Title - Sujet Palace Grand Theatre Renovation	
Solicitation No. - N° de l'invitation EZ899-171574/A	Amendment No. - N° modif. 006
Client Reference No. - N° de référence du client	Date 2016-12-02
GETS Reference No. - N° de référence de SEAG PW-\$PWY-028-7894	
File No. - N° de dossier PWY-6-39183 (028)	CCC No./N° CCC - FMS No./N° VME
Solicitation Closes - L'invitation prend fin at - à 02:00 PM on - le 2016-12-15	Time Zone Fuseau horaire Pacific Standard Time PST
F.O.B. - F.A.B. Plant-Usine: <input type="checkbox"/> Destination: <input checked="" type="checkbox"/> Other-Autre: <input type="checkbox"/>	
Address Enquiries to: - Adresser toutes questions à: Lam (PWY), Tian	Buyer Id - Id de l'acheteur pwy028
Telephone No. - N° de téléphone (604) 775-9382 ()	FAX No. - N° de FAX (604) 775-6633
Destination - of Goods, Services, and Construction: Destination - des biens, services et construction: PCA Parks Canada Agency - Palace Grand Theatre - Dawson City, YT

The Solicitation Amendment 006 is raised to incorporate Addendum No. 3

Please find Addendum A003 herein

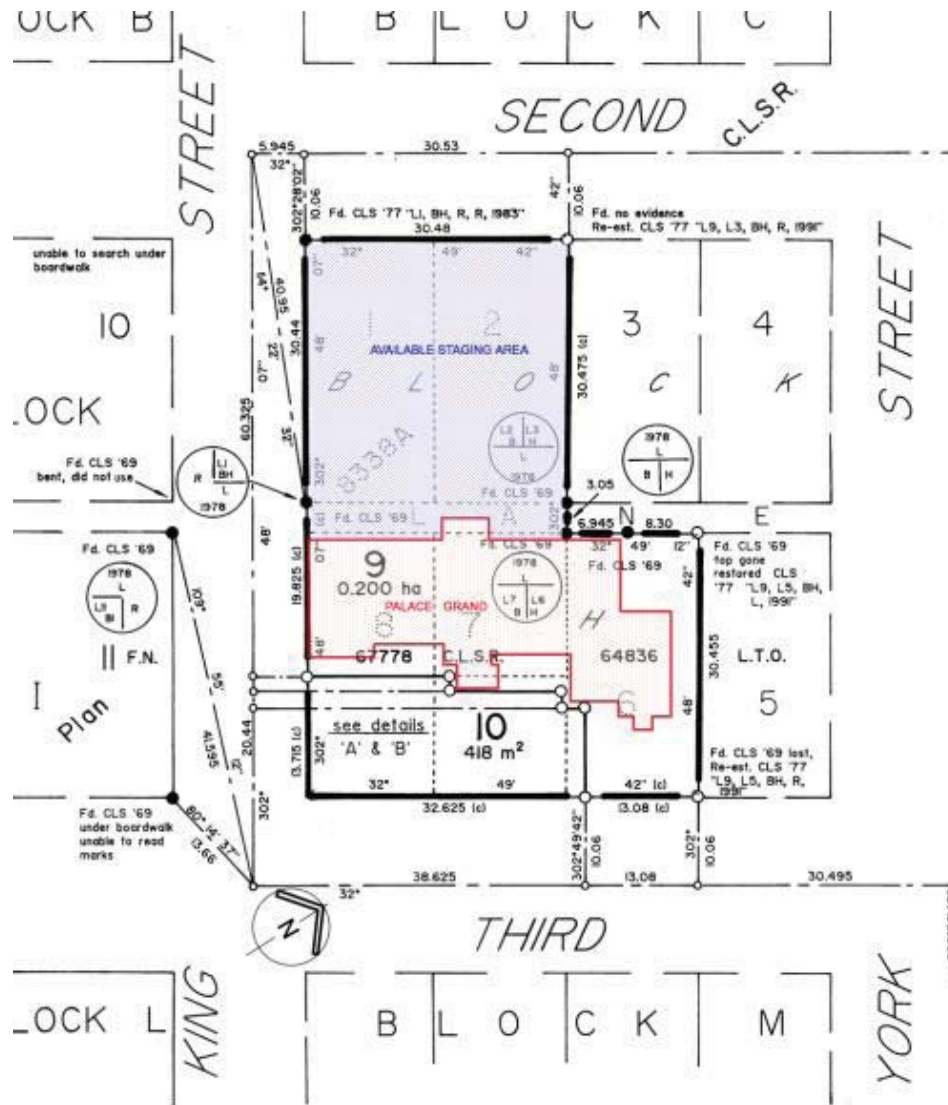
Q1	<u>Bidder</u>	<u>Question</u>	<u>Question Date</u>
	NGC Builders		Nov 24 -2016, email
		<i>'I am looking for contact information regarding the lot adjacent to the Palace Grand Theatre in Dawson City.</i>	
		<i>We would like to discuss arrangements for availability for staging during the project, as it is an empty lot.</i>	
		<i>Also, if there is a cost attached to this, we would need a value to include in our bid. I have a copy of the Certificate of Title indicating that it is Crown Land. (see attached doc)</i>	
		<i>Would you have any information as to whom to contact about this?"</i>

The two lots as depicted in the following sketch can be used for staging purposes, there will be no cost to the contractor to use these empty lots.
After project completion, the lots should be in, as found condition or better.
